Subject ▶ Change on position of lock lever

For Models ▶ 3612C (Electronic Router)

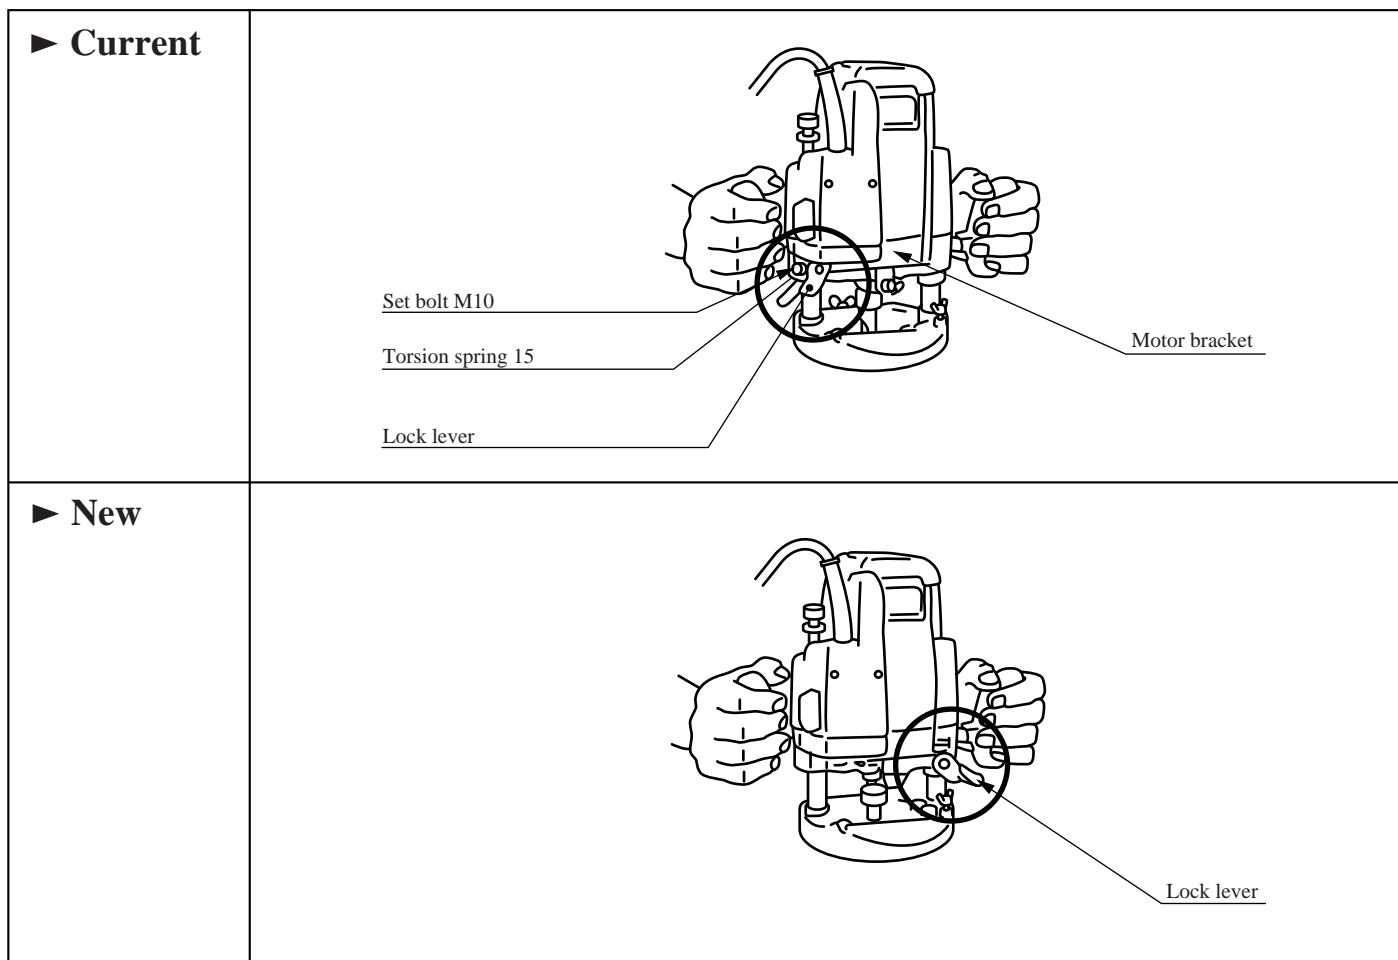
Description ▶ The position of lock lever will be changed as follows.

Item No.	Current part		Q'ty	I/C	New part		Q'ty	Note
26	Lock lever 341933-3		1	No	Lock lever 344097-2		1	Interchangeable as a set
16	Motor bracket 150380-5		1	No	Motor bracket 150443-7		1	
24	Torsion spring 15 231574-2		1	No	Torsion spring 15 231618-8		1	
25	Set bolt M10 265813-8		1	No	Set bolt M10 266015-9		1

From serial No. 1027E
